STAFF RECOMMENDATION

Project: Wallace Cottages Housing Design Demonstration Project Preliminary Subdivision

File No: PLN 50589 SUB

Date: December 28th, 2017
To: Kelly Tayara, Associate Planner, Planning and Comm. Development
From: Peter Corelis, P.E., Development Engineer
Subject: PLN50589B SUB – Wallace Cottages HDDP Subdivision

UTILITY PLAN
WALLACE COTTAGES
HDDP PRELIMINARY PLAT SUBMITTAL

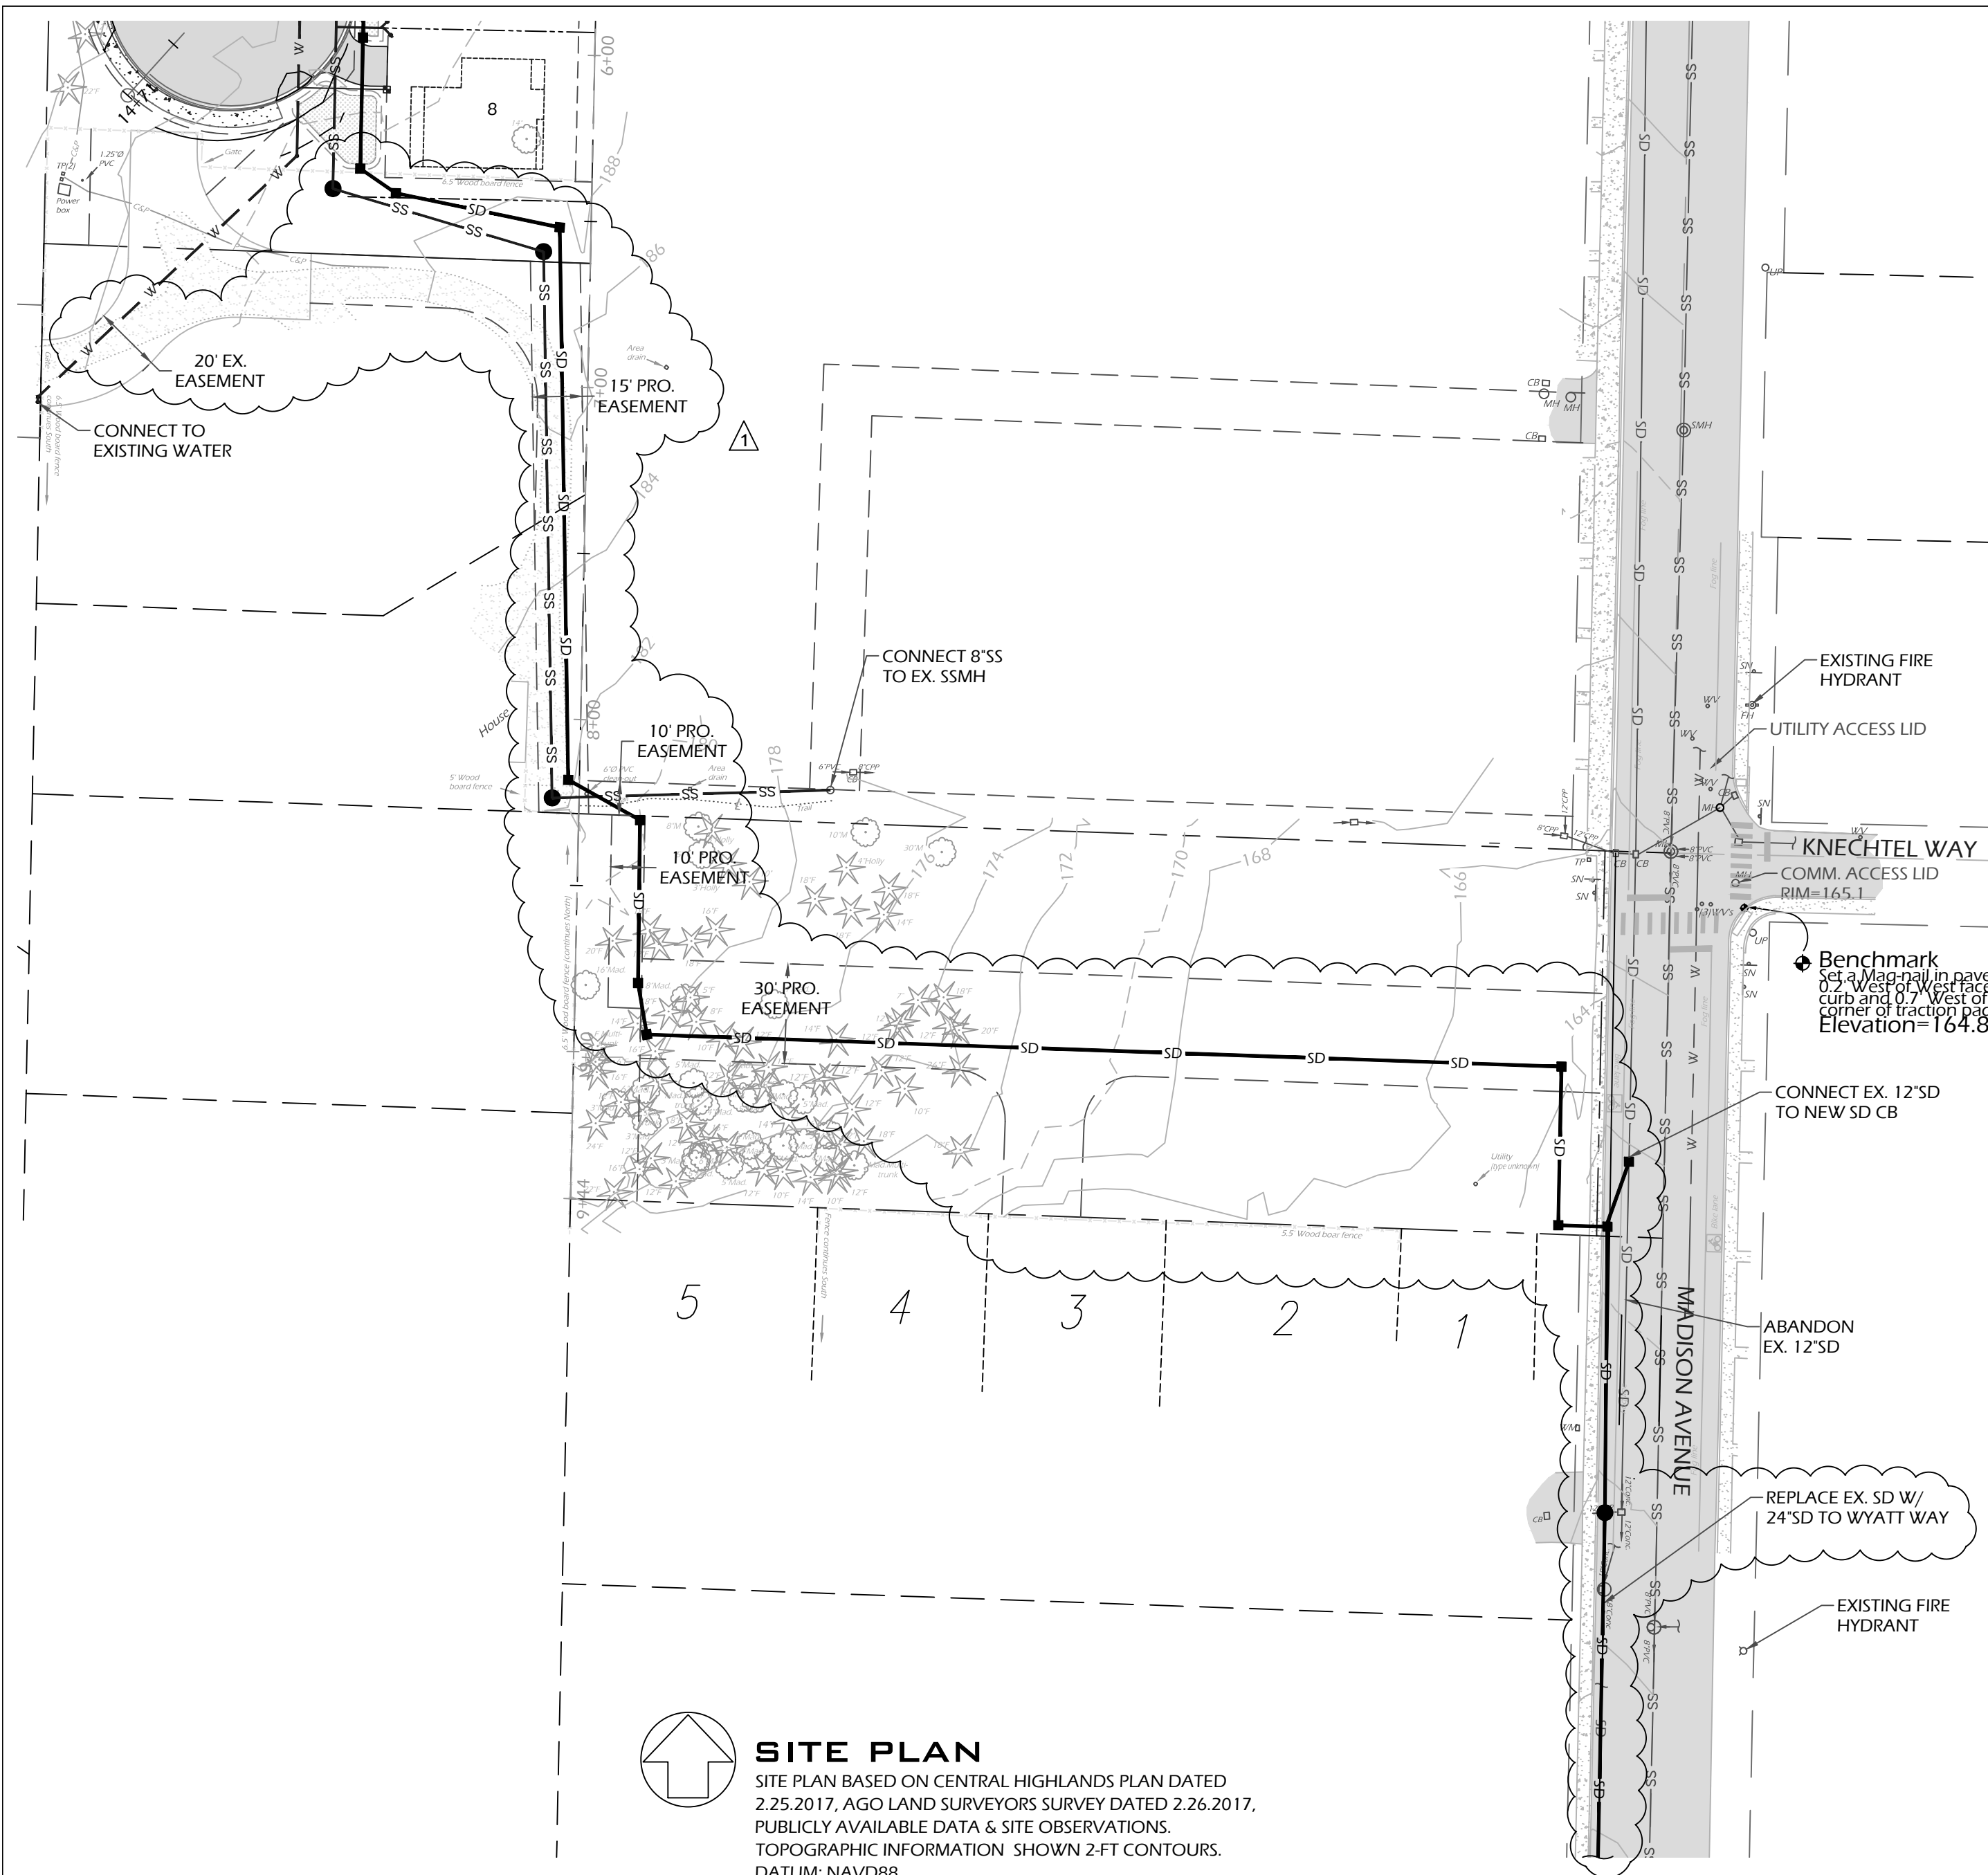
8. The proposed 8-inch water main extension from Madison Avenue to the Wallace Way NW right-of-way extension shall be located to allow both a minimum 10 feet of separation of the water main from the existing sewer main and provide adequate setback from the northern property line to allow for construction, maintenance, and servicing of the new main. If additional ROW or easement is required it shall be provided. Alternatively, a looped water main system may be accomplished by routing the water line in from Wallace Way NW from Nakata Avenue NW.

9. The water main extension from the Fir Acres Drive ROW at the south end of the project shall be located within existing or proposed easements and provide a minimum 10 feet clearance to the edge of the easement.

WALLACE W RD PLAN, PROFILE & SECTIONS
WALLACE COTTAGES
HDDP PRELIMINARY PLAT SUBMITTAL

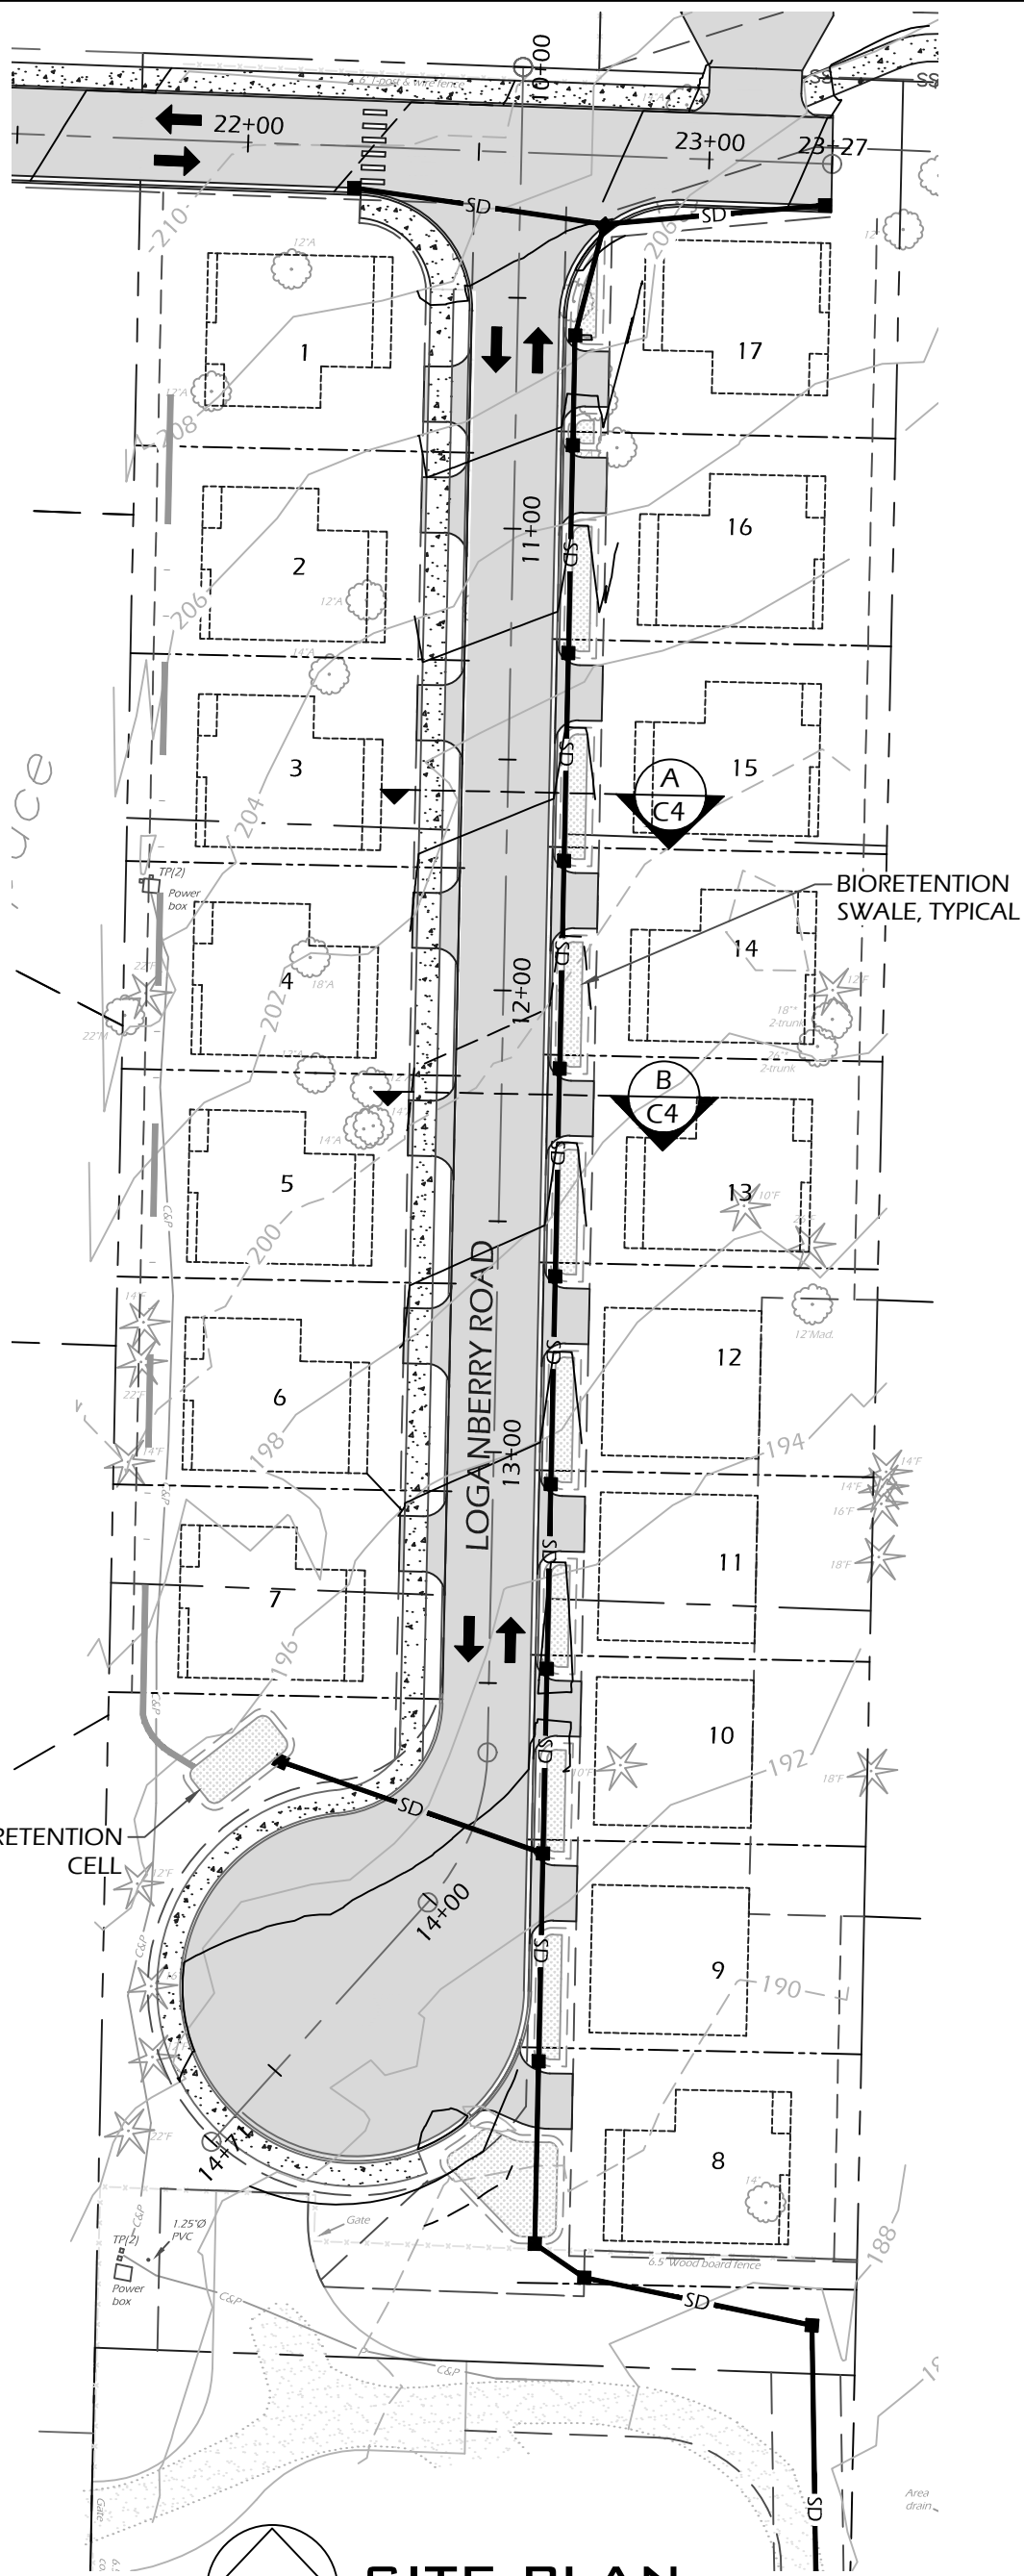
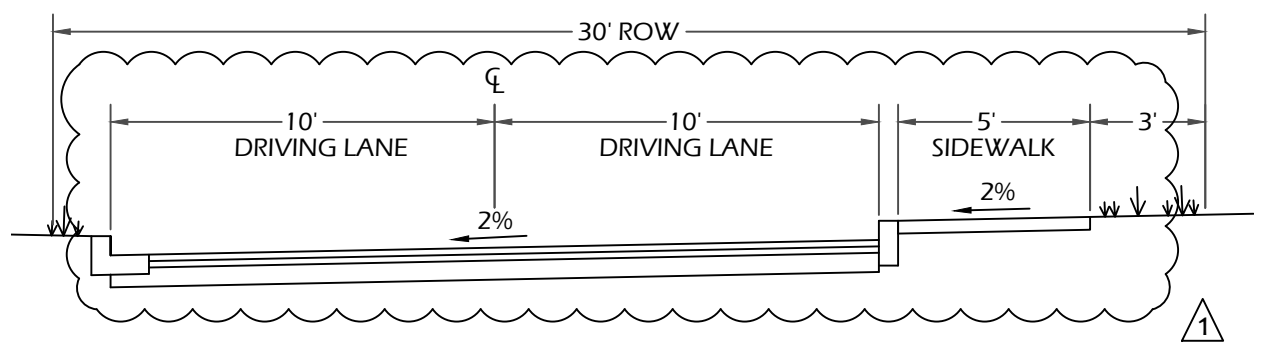
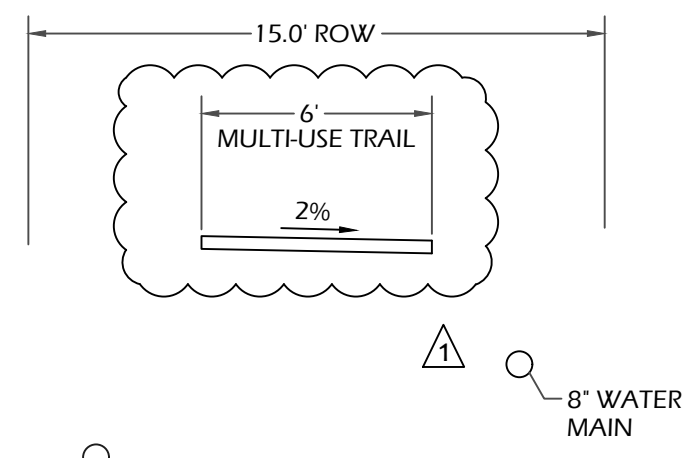
17. The east/west plat access road extension of Wallace Way NW shall meet the standards of an urban local access street per standard drawing DWG. 7-050 of the Standards, except as noted. The plat access road shall provide two (2) 9-foot travel lanes for two-way traffic circulation, with 1-foot gutter pans and vertical curbs to provide a clear curb-curb distance of 20 feet. Sidewalks shall be provided on one side. A minimum of 30 feet of right-of-way for the road section and sidewalk shall be dedicated to the City.

LOGANBERRY RD PLAN, PROFILE & SECTIONS WALLACE COTTAGES HDDP PRELIMINARY PLAT SUBMITTAL

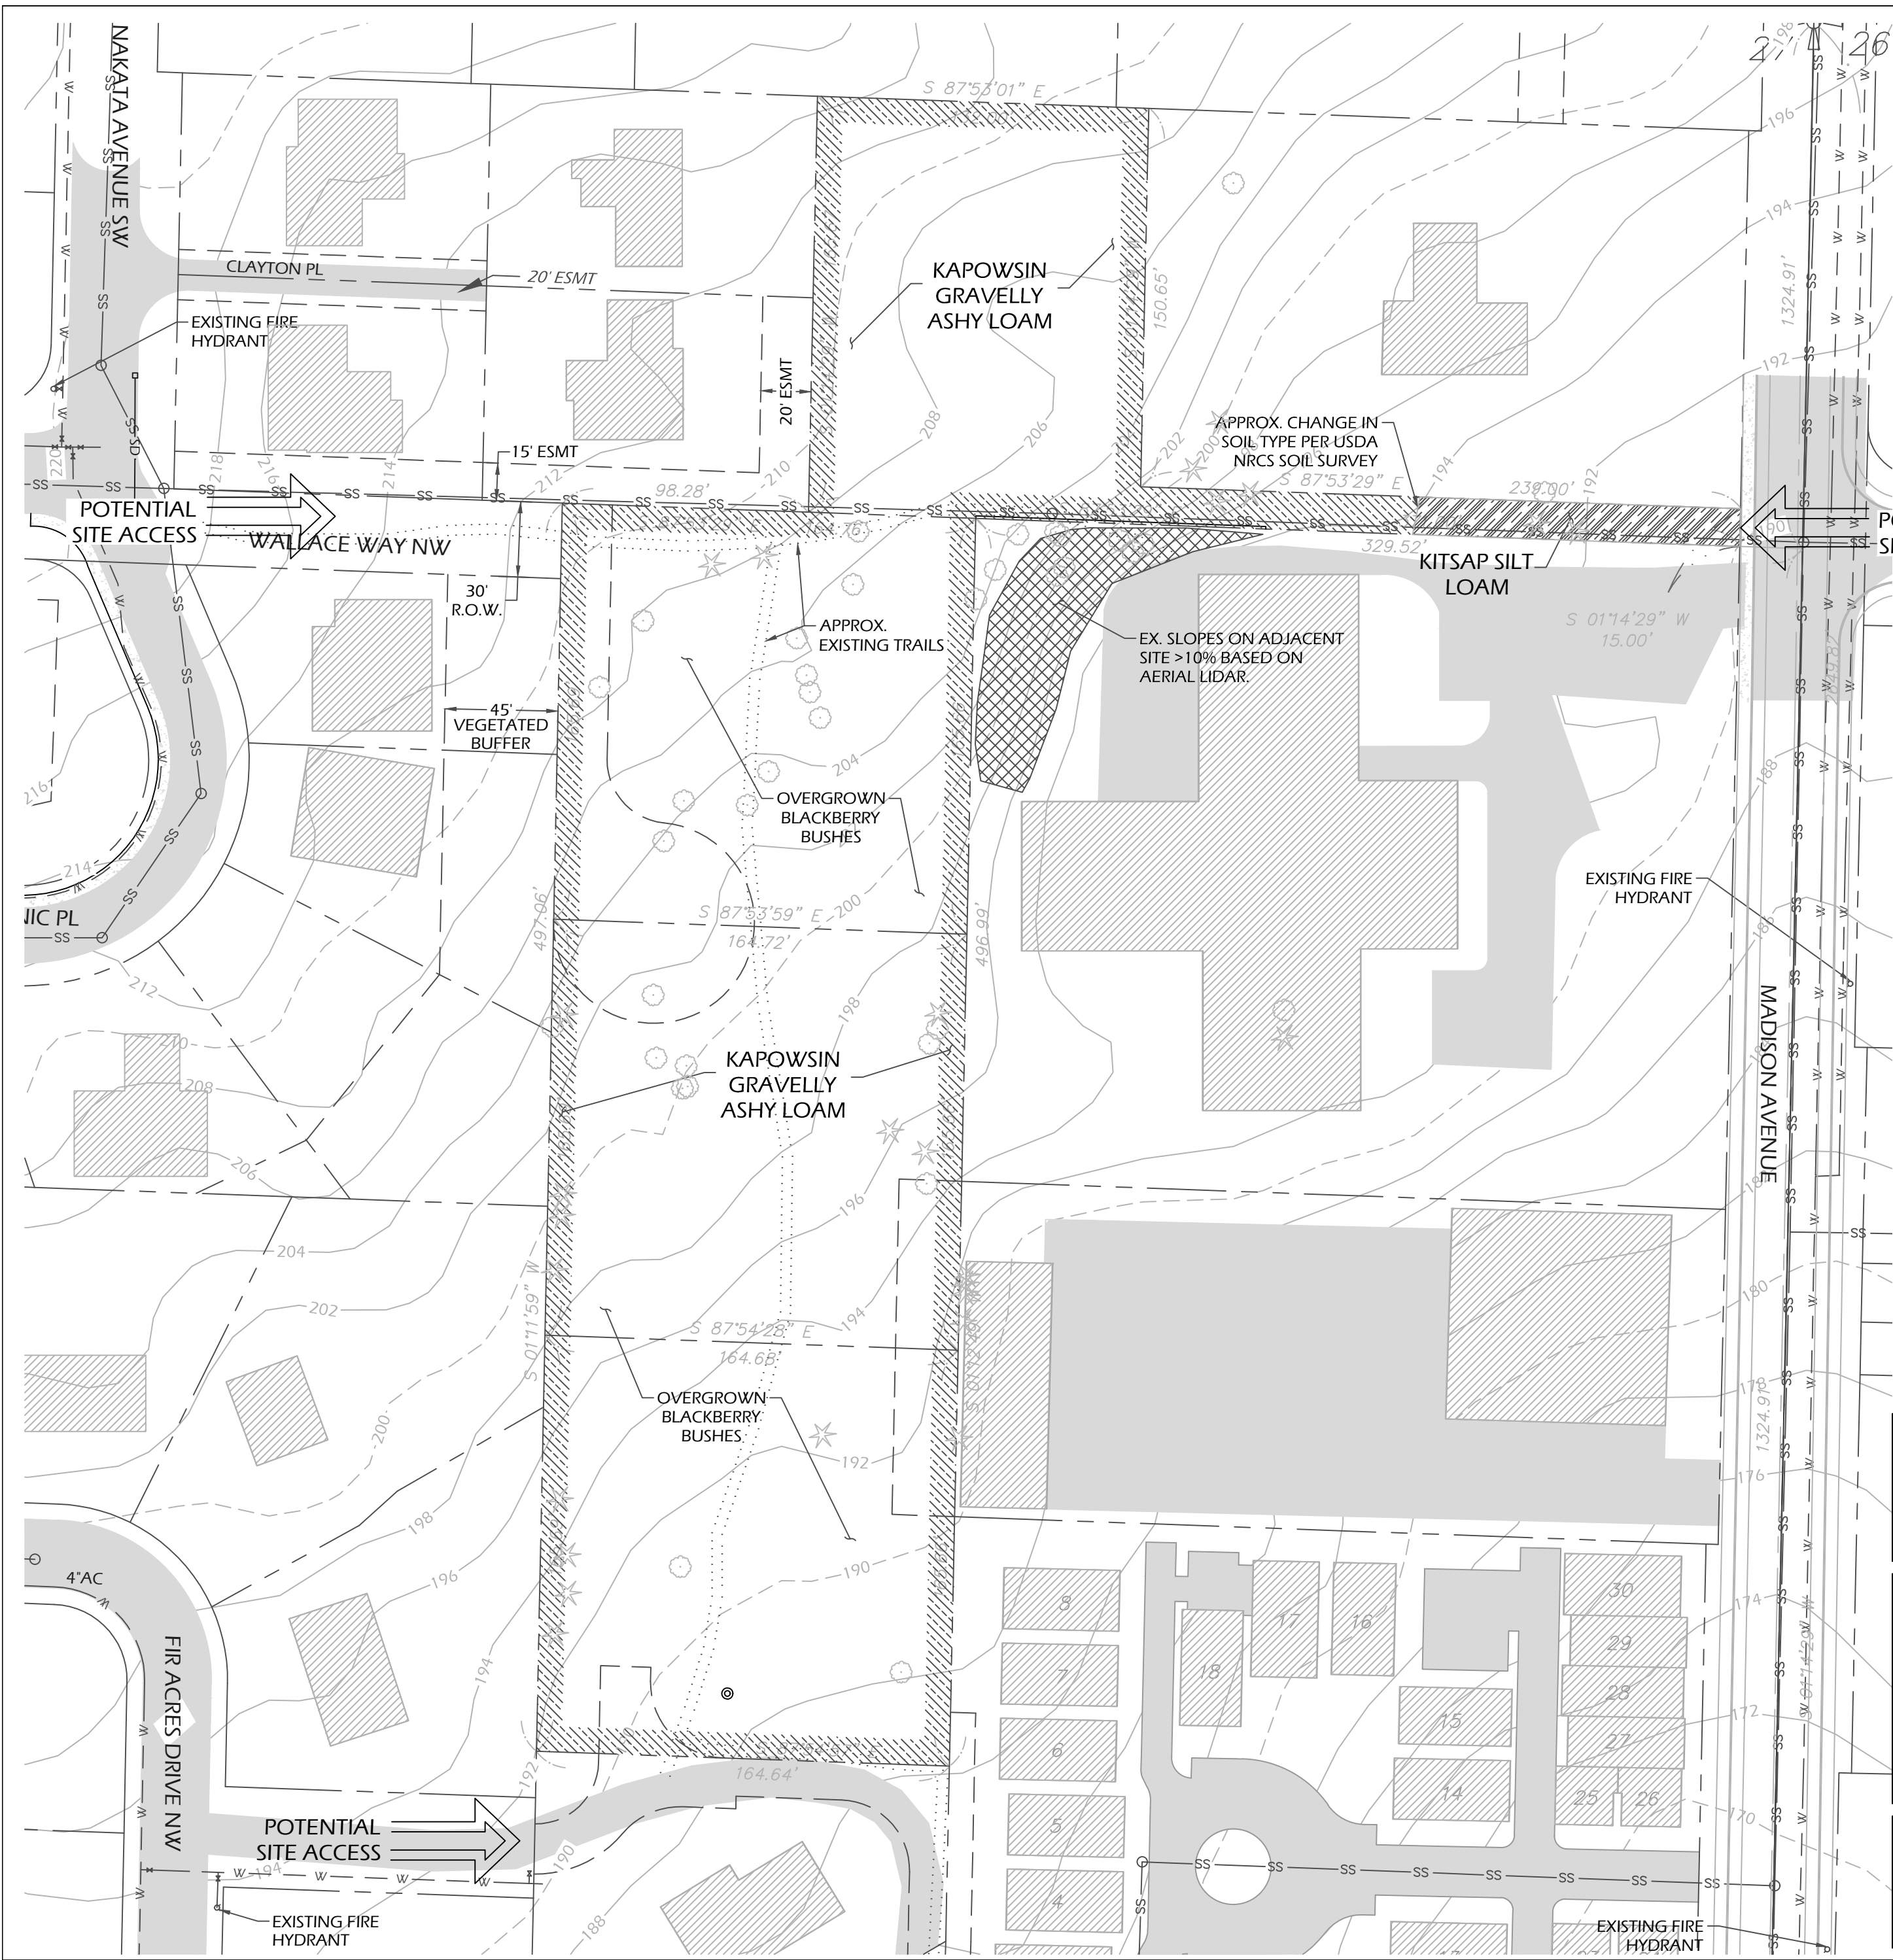
16. The north/south plat access road identified as Loganberry Road NE on the preliminary civil plans, shall meet the standards of an urban local access street per standard drawing DWG. 7-050 of the Standards, except as noted: The plat access road shall provide two (2) 9-foot travel lanes for two-way traffic circulation, with 1-foot gutter pans and vertical curbs to provide a clear curb-curb distance of 20 feet. Sidewalks shall be provided on one side with a minimum 3-foot wide planter strip. A minimum of 20 feet of right-of-way for the road section and 10-foot easements on either side shall be dedicated to the City to provide a combined 40-feet of ROW and easement dedication for access and utilities.
